## ATTACHMENT B

Project: City of Fresno Animal Shelter

**EXHIBIT B**  
**PRE BID RFIS**

## RFI 0002 - Building A - Built-in Tall Cabinet Elevations

A-1.4 (See page 2)

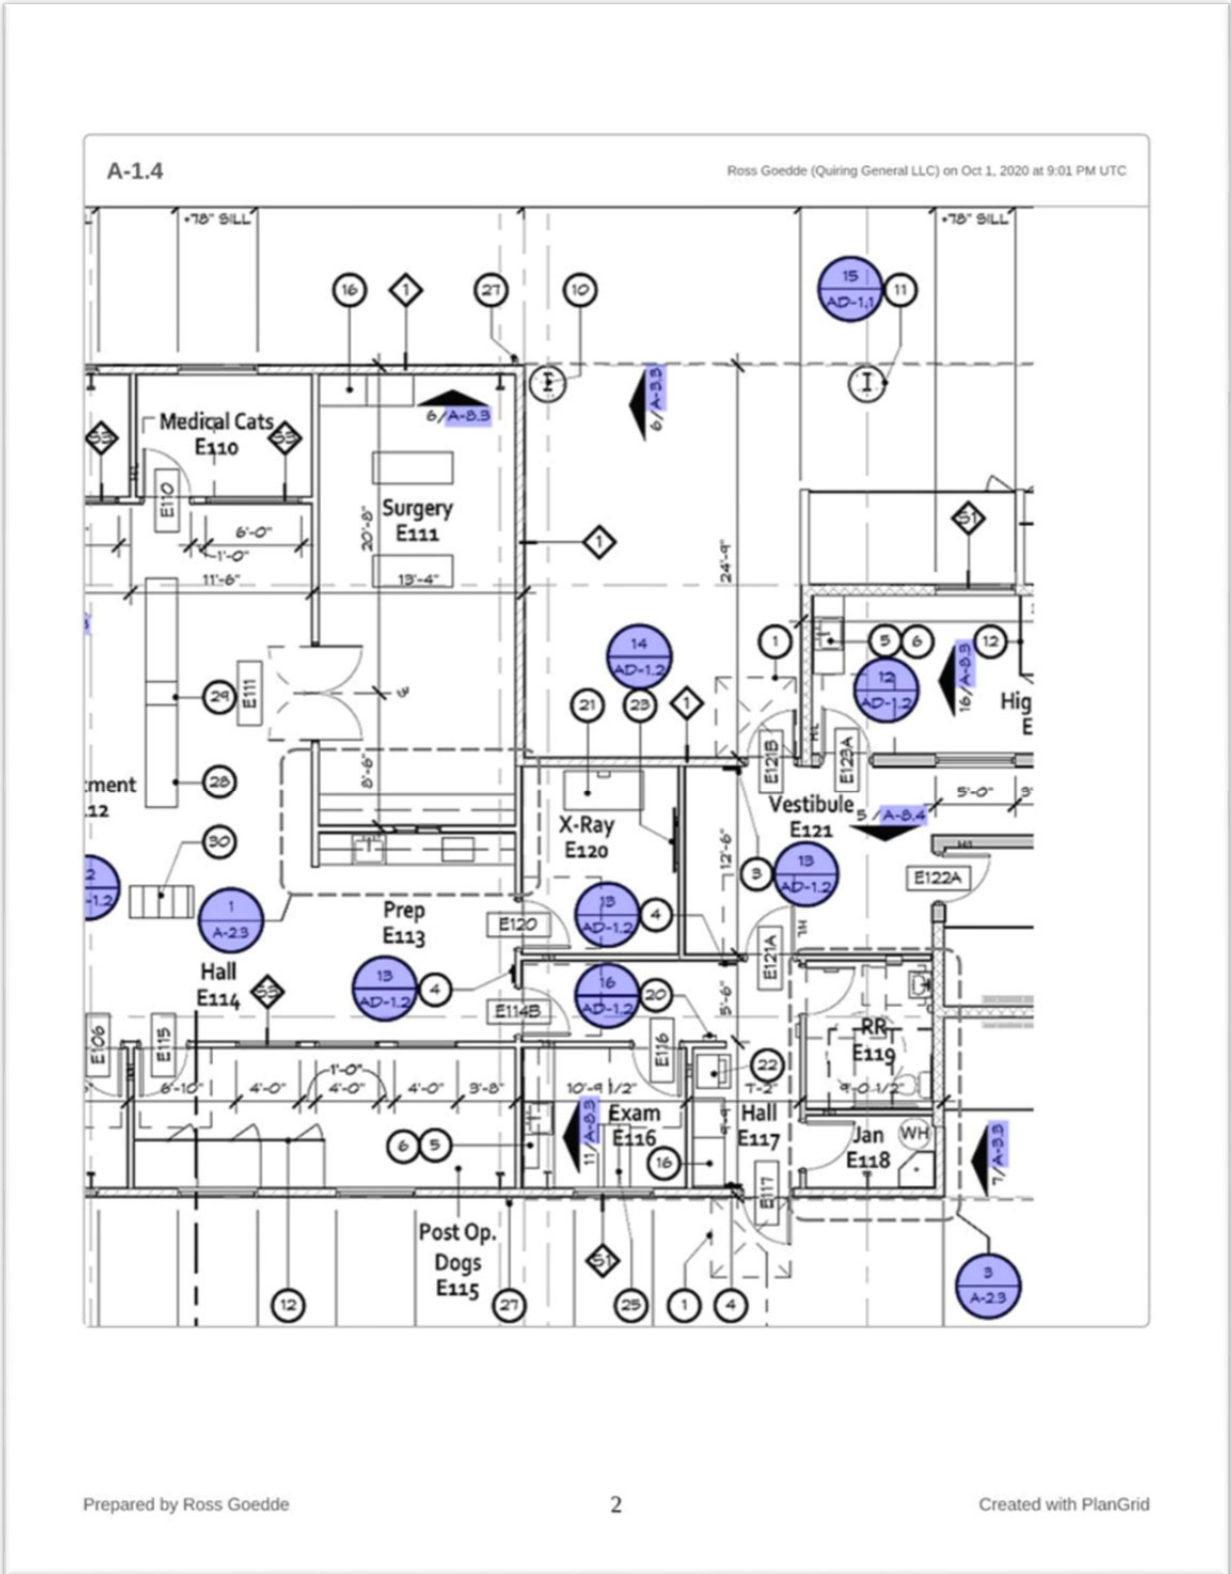
Building E, Keynote 16 calls out "Built-in tall cabinets" in Hall E117, but there is no elevation given for that location.

Keynote 16 is also called out in Surgery E111, for which elevation 6/A-8.3 is provided.

Please confirm that elevation 6/A-8.3 applies as a similar elevation for Hall E117.

Yes, please provide base on elevation shown, all tall cabinets shall be typical.

A-8.3

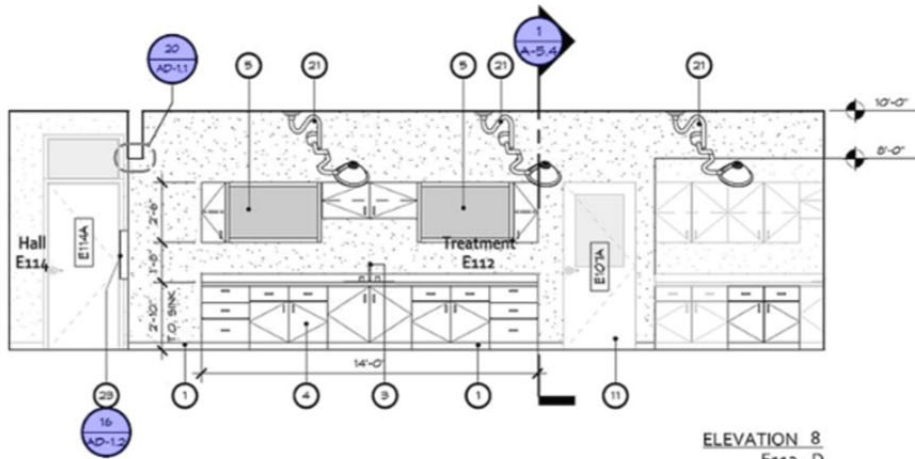
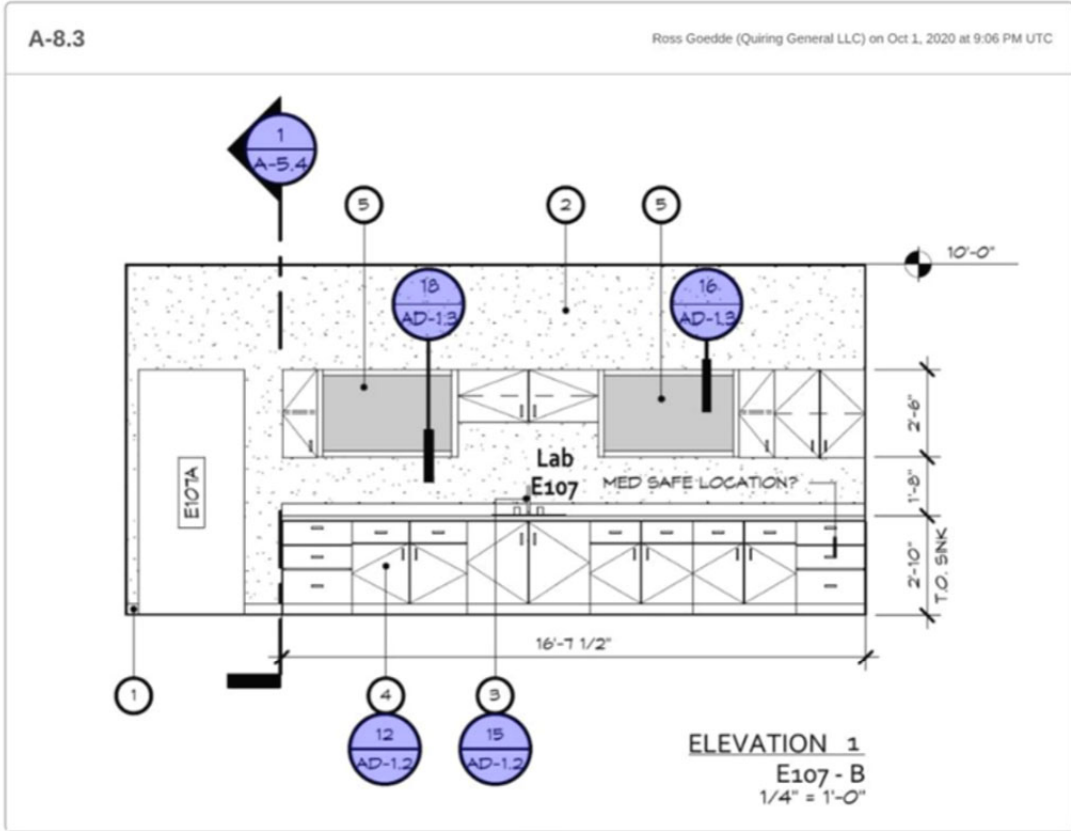
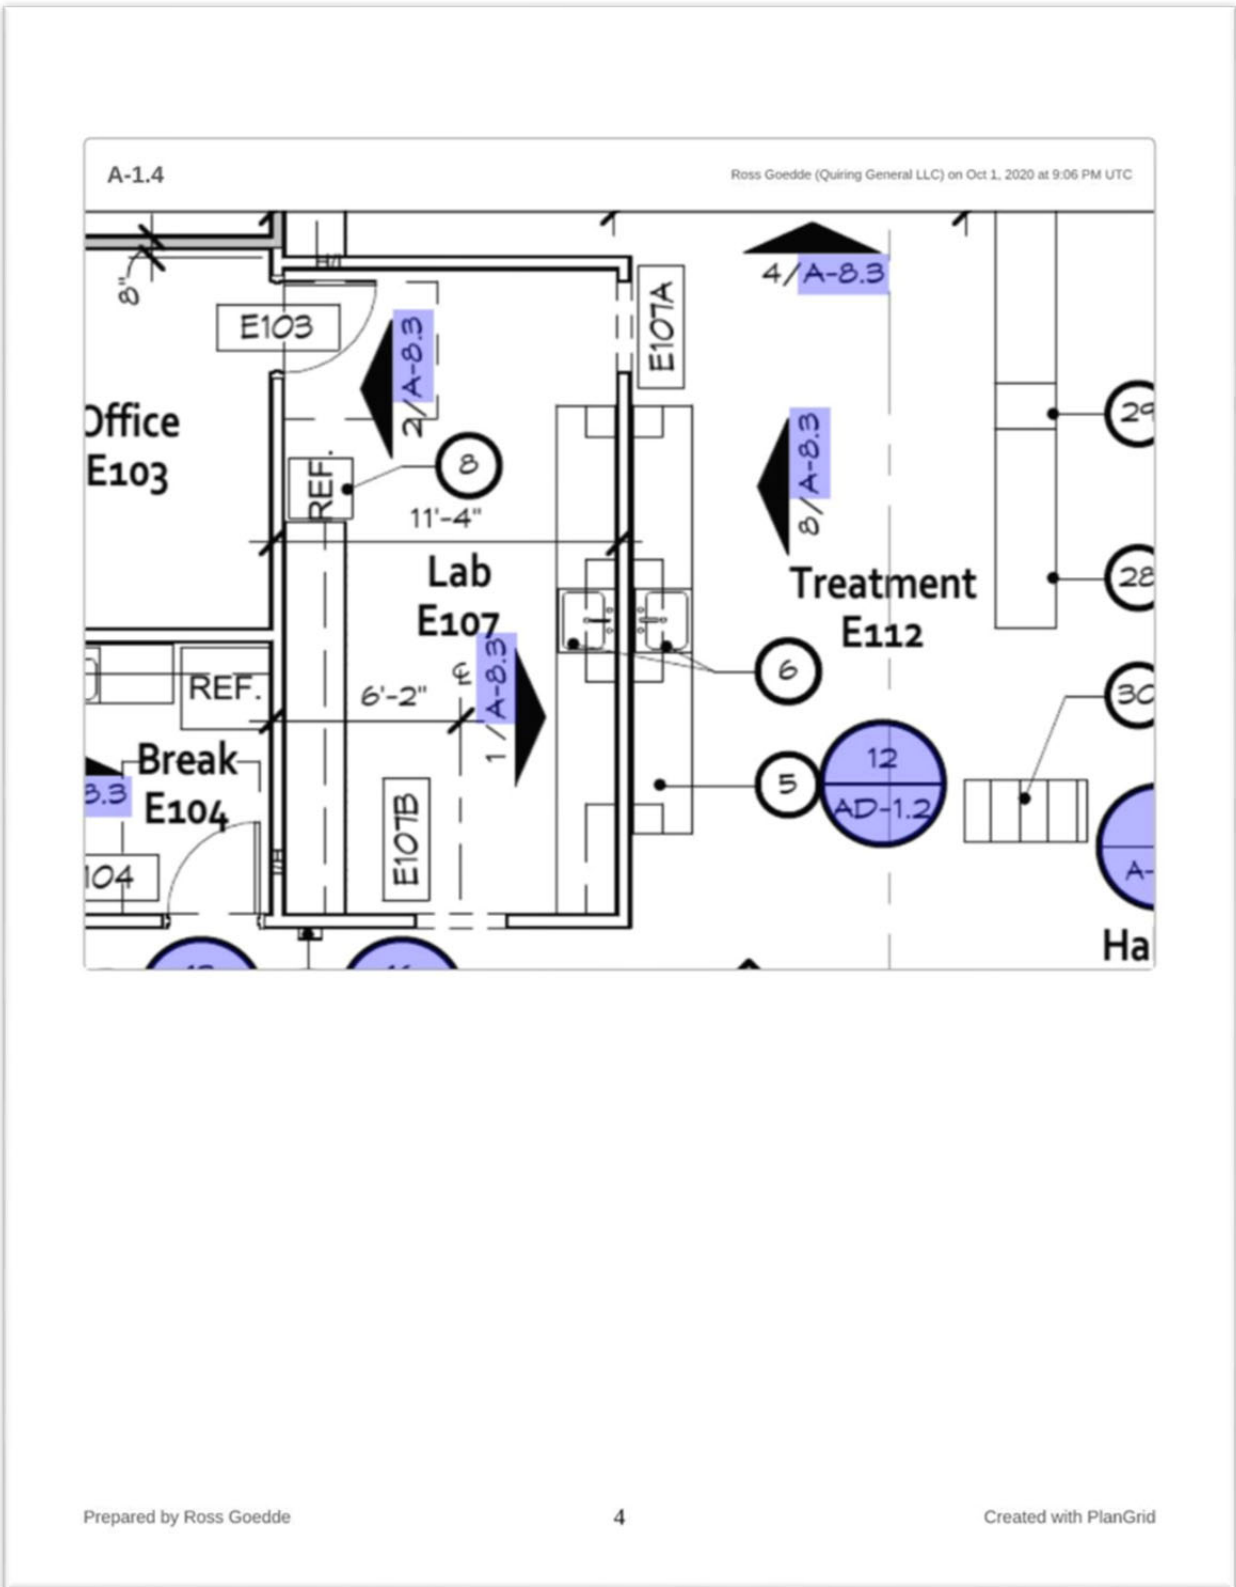
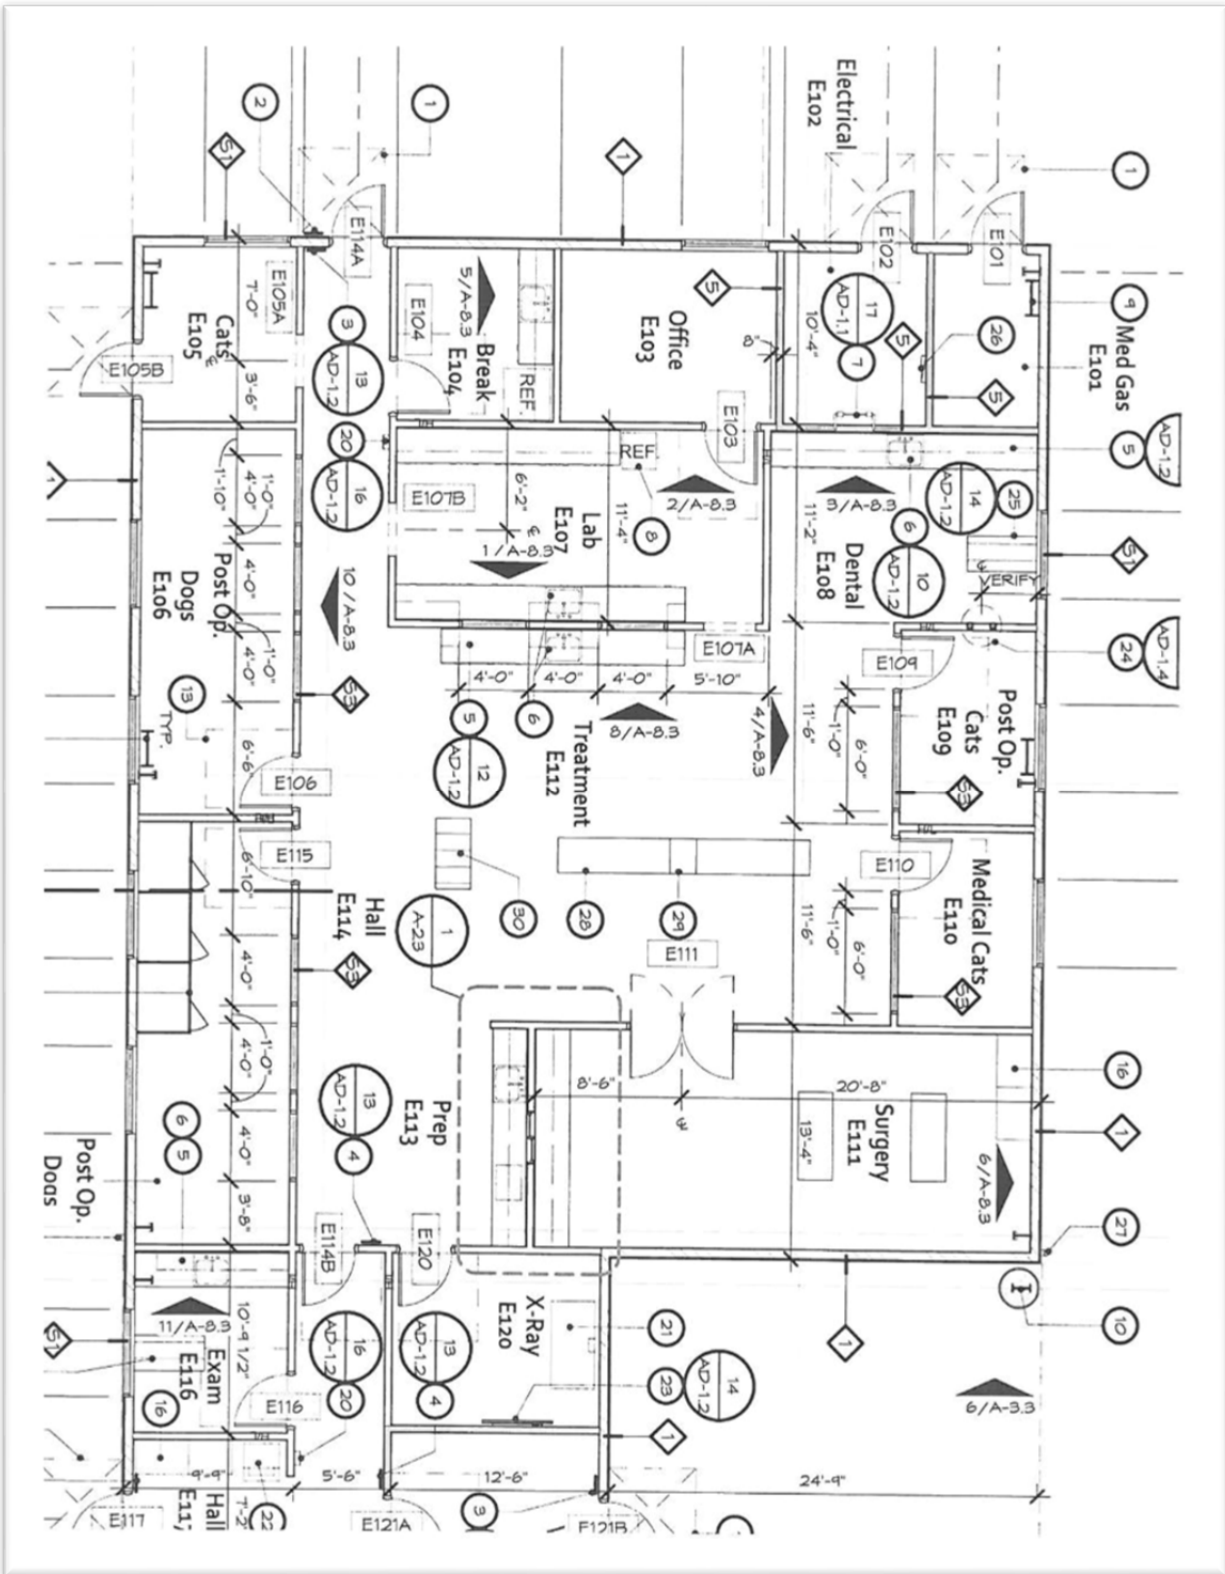
Elevations 1 & 8 on A-8.3 show two interior storefront windows between Lab E107 and Treatment E112.  
A-1.4 shows the upper cabinets spaced to accommodate such windows, but the windows themselves are not shown.  
Please confirm that the windows are to be installed per elevations 1 & 8 on A-8.3.

Please see attached floor plan.

## RFI 0006 - Miscellaneous CMU Questions

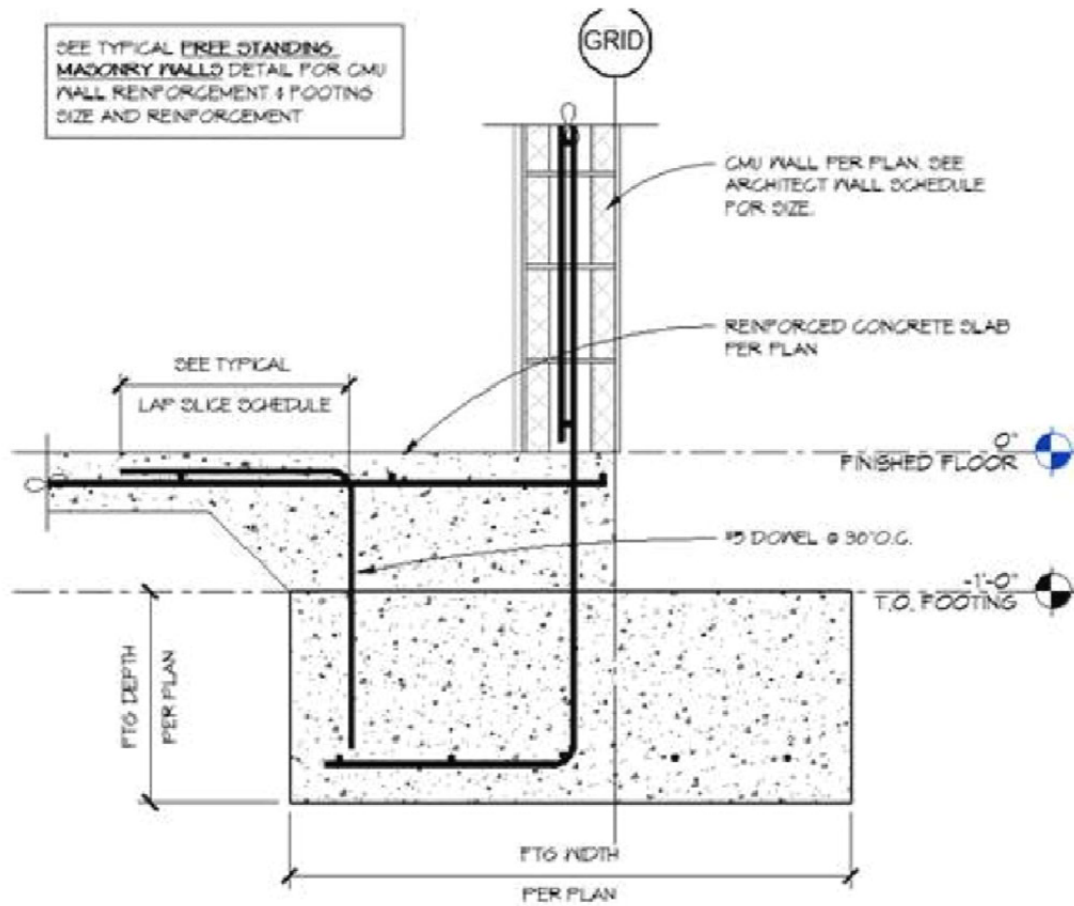
1. Confirm the CMU walls are to sit directly on the slab (no 4" curb).
2. Please provide detail 12/S501
3. Confirm the height of CMU kennel dividing walls (wall type M2).
4. Provide a connection detail between the building exterior CMU walls and the kennel dividing CMU walls.

**ASSUME ALL KENNEL WALLS SIT DIRECTLY ON THE SLAB. THE 4" CONCRETE CURB SHOWN IN 4/A-1.2 ONLY APPLIES AT THE PASS THROUGH FOR THE ANIMALS TO MOVE FROM INTERIOR TO EXTERIOR.**

<b>12</b>		<b>DETAIL</b>
S402	S501	1" = 1'-0"

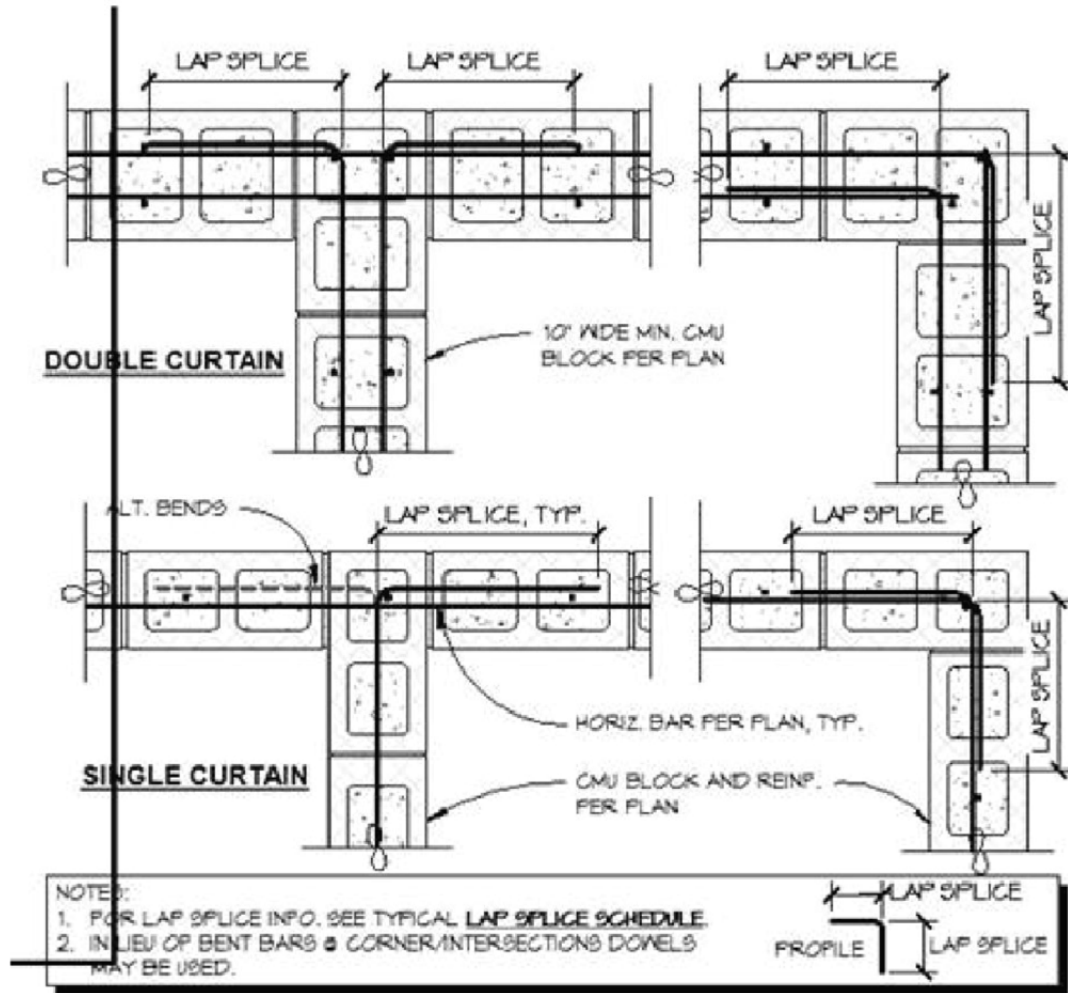
There are some spots in the drawings that show a 4" curb under masonry walls at kennels, while other seem to call for the masonry to sit directly on the slab. Sections for this condition callout detail 12/S501, but this detail does not exist.

**DETAIL 12/S501. ASSUME SIMILAR WITH STEM WALL FOR CMU WALLS THAT DIVIDE EXTERIOR KENNELS**

<b>8</b>	<b>CORNERS AND INTERSECTIONS (CMU)</b>
S104	NOT TO SCALE

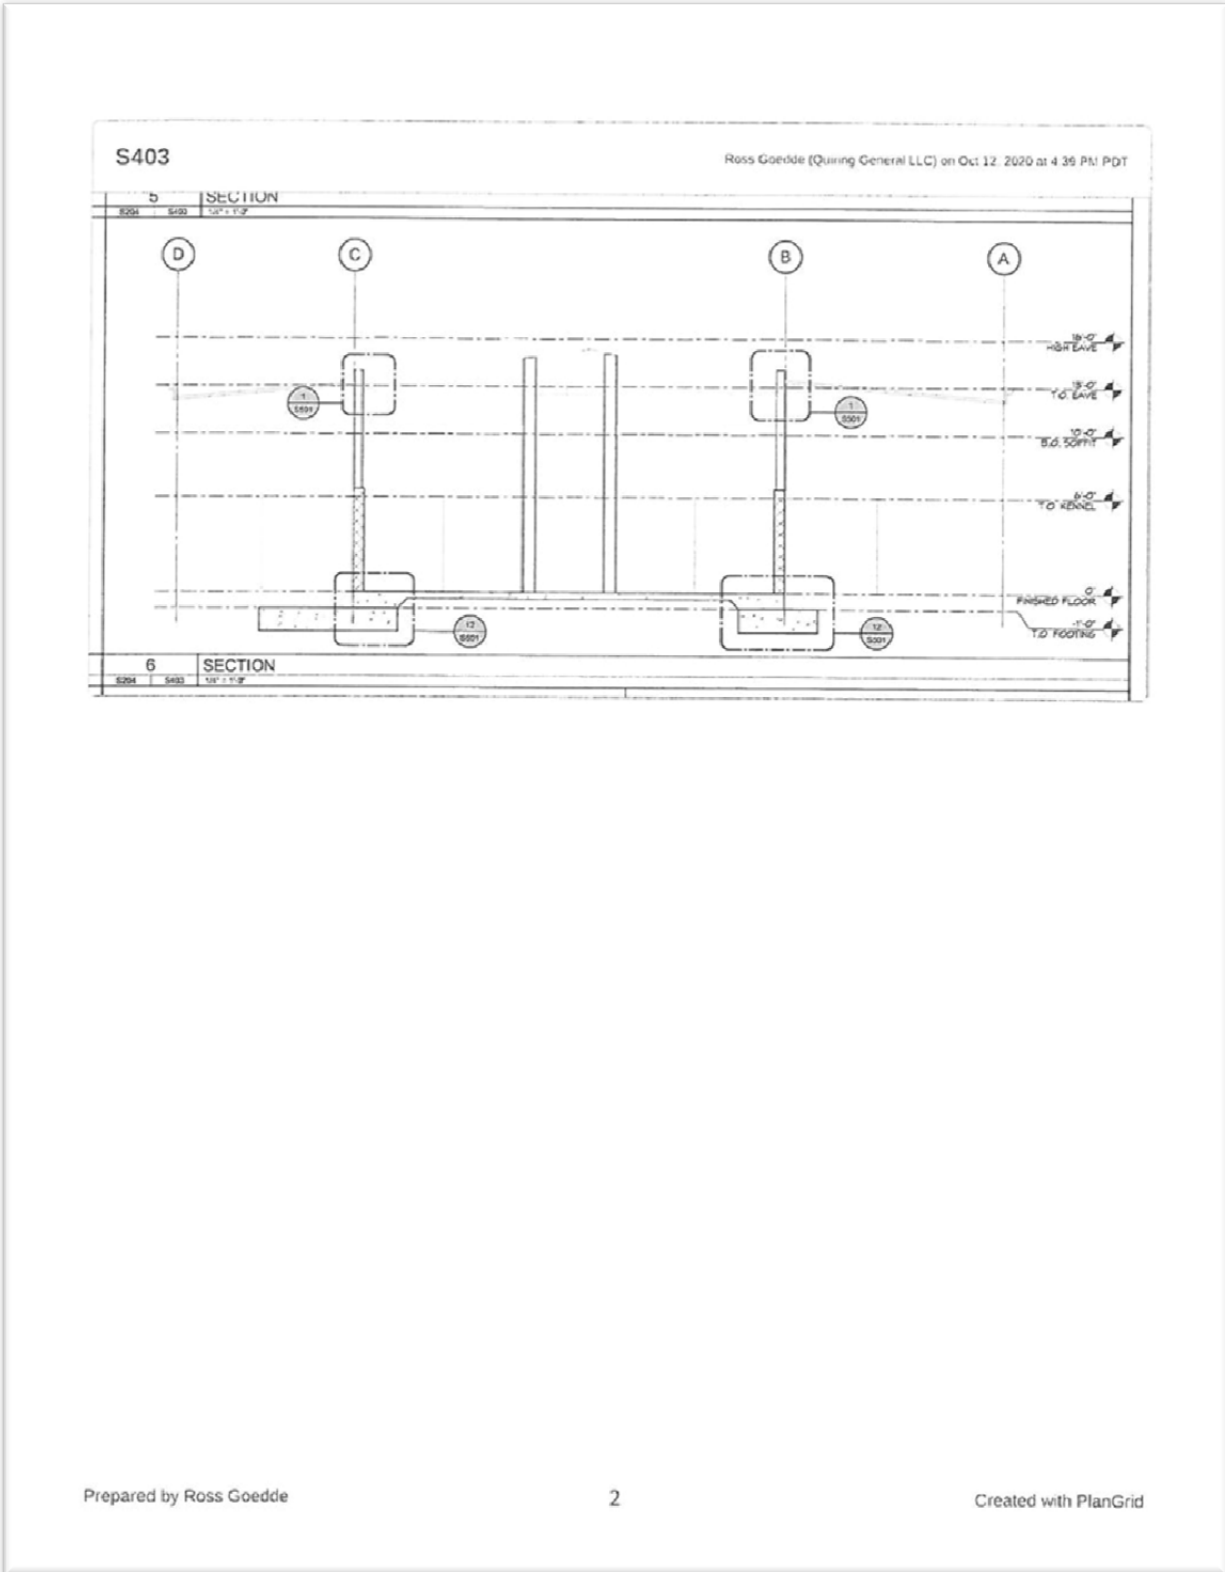
There is no connection detail between the building exterior CMU walls, and the kennel dividing CMU walls.

DETAIL SHOWING TRANSITION BETWEEN BUILDING EXTERIOR CMU, AND CMU THAT DIVIDES KENNELS.
